ATTN: Document Control Desk  
U. S. Nuclear Regulatory Commission  
Washington, DC 20555-0001**SUBJECT:**Beaver Valley Power Station, Unit Nos. 1 and 2  
BVPS-1 Docket No. 50-334, License No. DPR-66  
BVPS-2 Docket No. 50-412, License No. NPF-73  
Response to Request for Additional Information Related to Generic Letter 2004-02  
(TAC Nos. MC4665 and MC4666)

1. Response to Request for Additional Information Regarding the Supplemental Responses to Generic Letter 2004-02 for Beaver Valley Power Station Unit No. 1 (BVPS-1) and Unit No. 2 (BVPS-2)
2. Regulatory Commitment List

Response to Request for Additional Information Regarding the Supplemental  
Responses to Generic Letter 2004-02 for Beaver Valley Power Station Unit No. 1  
(BVPS-1) and Unit No. 2 (BVPS-2)  
Page 1 of 132

Figure 3-1, BVPS-2 Reactor Cavity Insulation and Neutron Shield Details

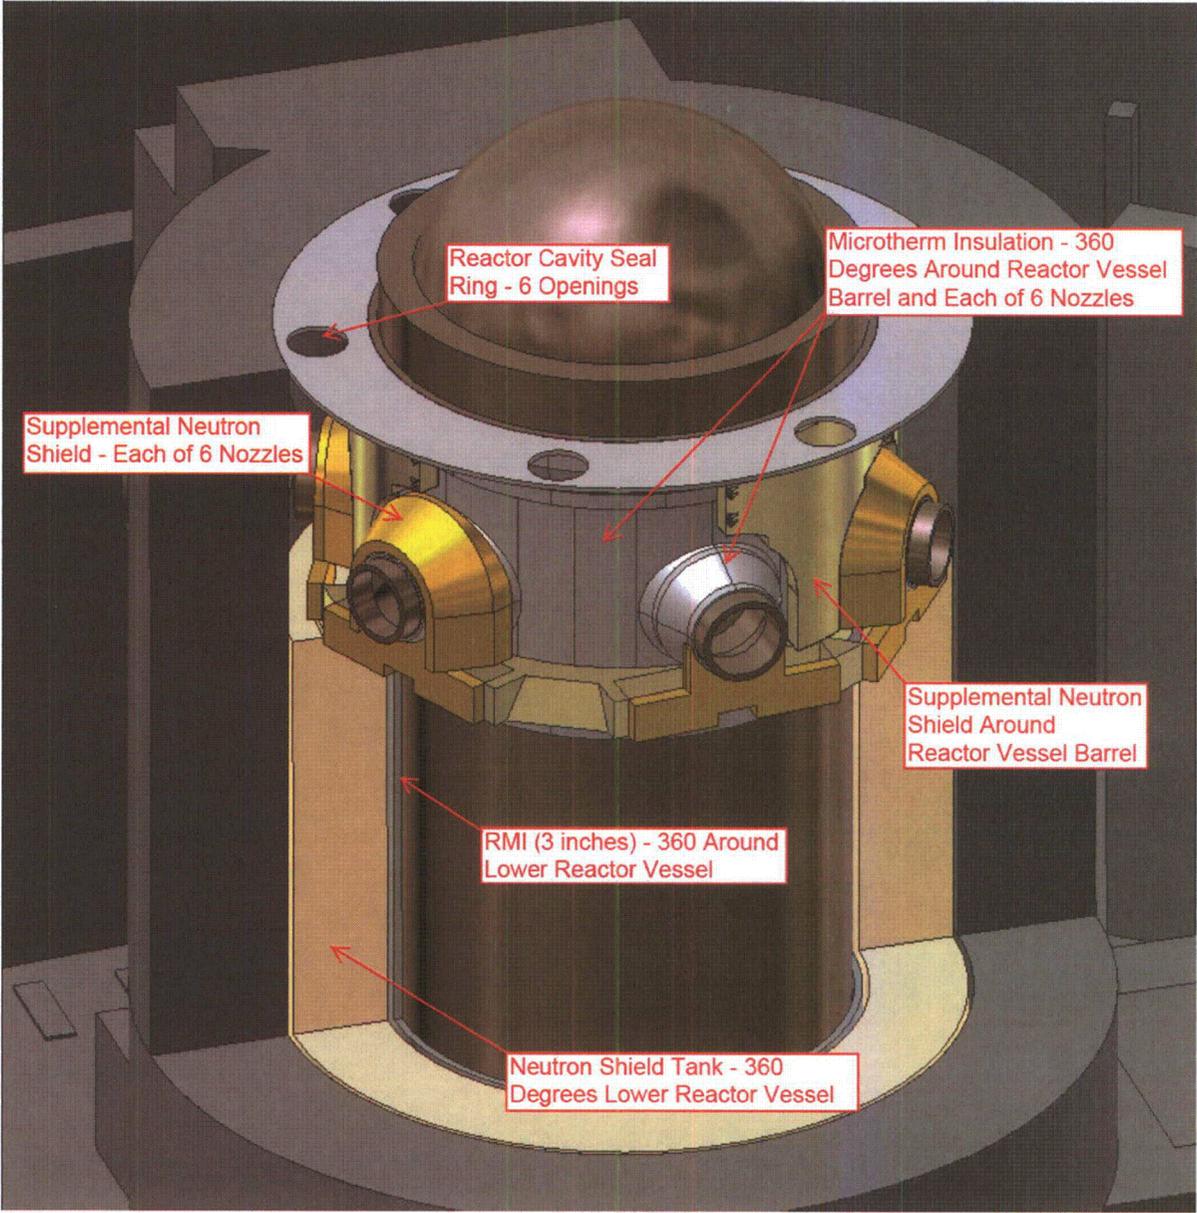
**Please provide additional details and assumptions on the alternate ZOI calculated for the Microtherm insulation installed on the RCS for BVPS-2, to describe how the ZOI was adjusted for the confined space within the reactor annulus. In Reference 1, it is stated that the alternate ZOI was calculated using the Boiling Water Reactor Owners Group Utility Resolution Guidance method 3 for restrained**

**breaks and was adjusted for the confined volume in the reactor annulus. Please provide details on the installation of the piping, insulation, and other structures or components that could affect the calculation, including how the axial and radial offsets were determined for the piping, the location of the insulation relative to the piping, pipe wall thickness, postulated break locations, whether longitudinal pipe breaks were considered, the destruction pressure used for the evaluation, etc. Please discuss whether a pancake-shaped jet as described in ANSI/ANS-58-2-1988 was evaluated, justify that a spherical ZOI is appropriate for the postulated restrained break, or describe how the jet was evaluated to behave within the confines of the reactor annulus. Provide information that describes how the amount of Microtherm debris would change with respect to the size of the ZOI. A non-conservative treatment of Microtherm would likely result in non-conservative head loss inputs. The Microtherm head loss is the bounding case for BVPS-2.**

The location of the Microtherm<sup>®</sup> insulation and the design configuration of the reactor coolant loop piping penetrating the reactor cavity wall are shown on Figure 3-1 and

Figure 3-2, respectively. Additional details on the configuration of the Microtherm<sup>®</sup> insulation and the supplemental neutron shield were presented on Attachment 1, page 20 of the June 30, 2009 supplemental response.

Figure 4-1, Benelex® Shield Ring Location

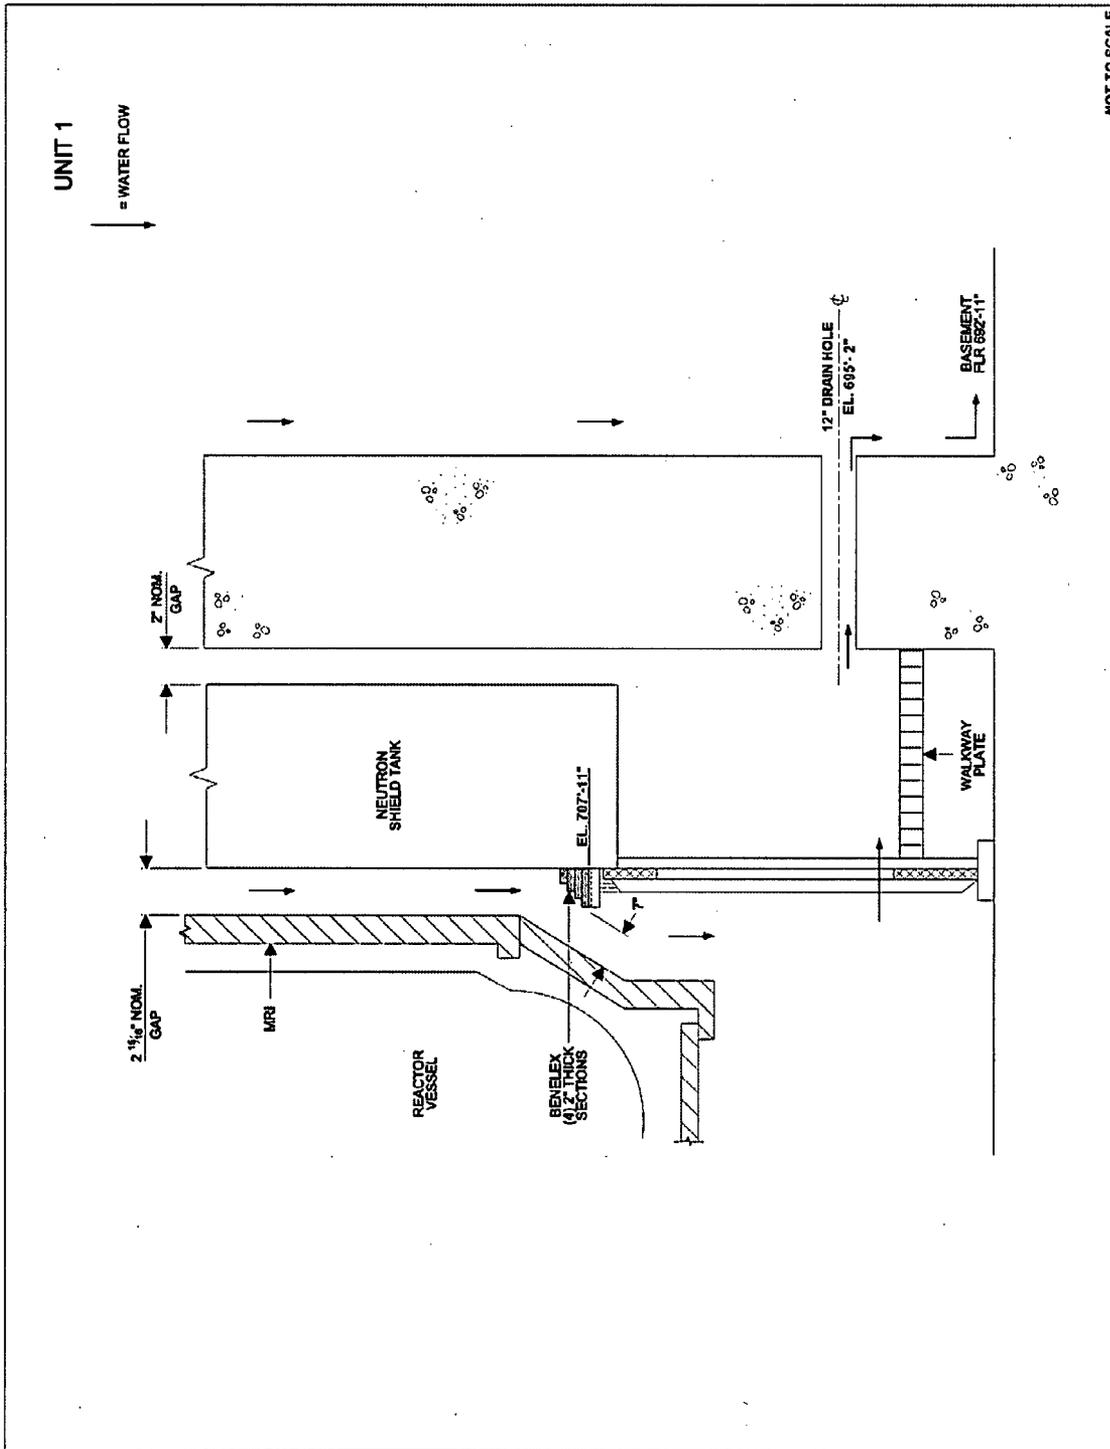
**In Reference 1, it is stated that Benelex 401 is a high-density wood-based material composed of cellulose and lignin fibers. The response stated that the material was evaluated for seismic forces and loss-of-coolant accident (LOCA) pressure loading, but did not specify the assumptions for the evaluation. It was not clear that the evaluation considered all aspects of impingement from a LOCA steam jet. Please provide additional information for the evaluation that determined that the ZOI for Benelex 401 would be limited to 2 diameters (D). Please describe the methodology and assumptions for this evaluation. State whether any testing was performed to determine the appropriate destruction pressure for the material. If testing was conducted provide adequate information to justify that the testing was representative of, or bounded, the conditions that would be expected in the plant at the assumed ZOI. State whether the material is considered to be water soluble. If so, please provide information that justifies that the material would not fail due to the post-LOCA environment and potentially transport to the strainer.**

Benelex<sup>®</sup> is used as a supplemental neutron shield near the bottom of the reactor vessel at BVPS-1, approximately 23 feet below the reactor vessel nozzles. The shield is comprised of four layers of two-inch thick Benelex<sup>®</sup> material shaped in the form of a large ring. The material is bolted together and supported by structural steel (as shown in Figure 4-1). The Benelex<sup>®</sup> shield ring does not perform any structural function. The material characteristics of Benelex<sup>®</sup> are described in detail in Section 3 of Appendix III to this RAI response attachment.

The reactor pressure vessel (RPV) nozzle breaks are postulated at the safe-end connections to the reactor coolant piping. It can be seen, as shown in Figure 4-2, that these break locations are above the top of the neutron shield tank, which is considered to be a robust barrier. The neutron shield tank will prevent direct jet impingement upon the Benelex<sup>®</sup> shield ring. Therefore, the only consideration for potential destruction of the Benelex<sup>®</sup> shield ring, as a result of a RPV nozzle break inside the reactor cavity,

Figure 19-1, BVPS-2 August 2009 Test 2 Differential Pressure and Velocity Versus Time, Flow Sweep Portion

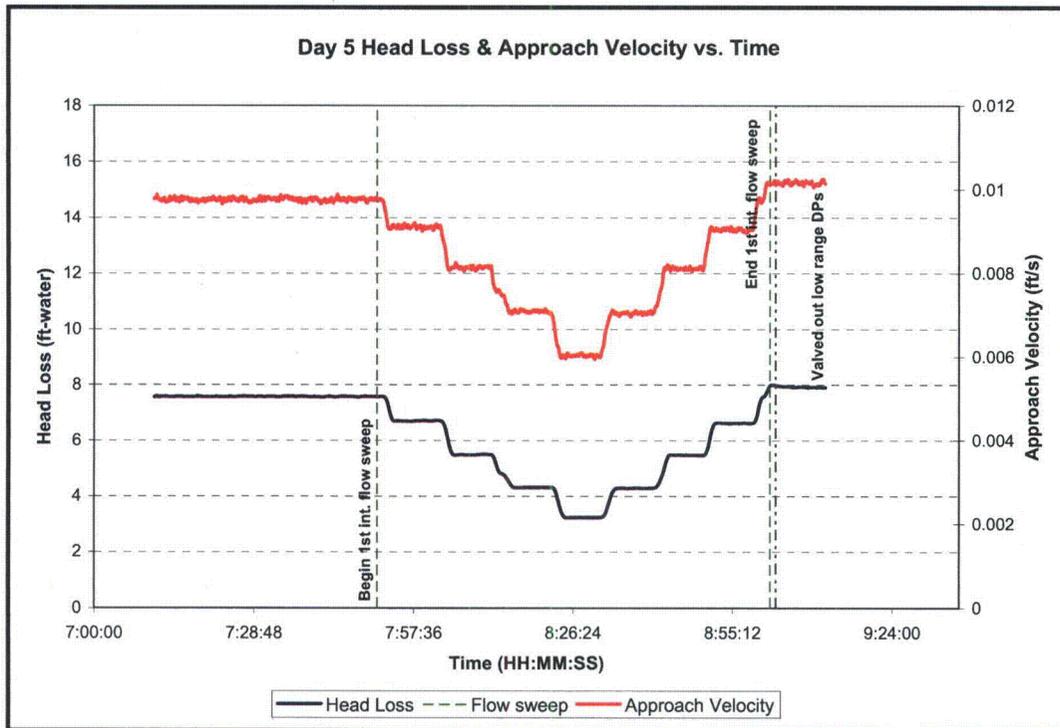
**The head loss graph, Figure 3.o.2.17-7 in Reference 1, shows that a flow sweep was conducted prior to the final debris addition and prior to the test reaching a stable value. Please provide the basis for this test sequence. Please provide information that justifies that the flow sweep did not affect the head loss result non-conservatively.**

In the June 30, 2009 supplemental response, Figure 3.o.2.17-7 shows a supplemental debris addition after the flow sweep. The flow sweep was conducted after the total design basis debris load had been added (non-chemical and chemical debris loads) and

Additionally, Figure 3.o.2.17-7 is applicable to BVPS-2 Test 5. At the time of the June 30, 2009 supplemental response, Test 5 represented the head loss for the reactor vessel nozzle break and bounded the maximum allowable Microtherm<sup>®</sup> debris load. However, as discussed in Appendix I of this RAI response attachment, BVPS-2 August 2009 Test 2 now represents the head loss for the reactor vessel nozzle break and bounds the maximum allowable Microtherm<sup>®</sup> debris load. Therefore, BVPS-2 Test 5 is superseded by the BVPS-2 August 2009 Test 2 and is no longer a design basis test.

Figure 19-1 provides the BVPS-2 August 2009 Test 2 Differential Pressure and Velocity Versus Time for the portion of the test when the flow sweep was performed following all debris additions.
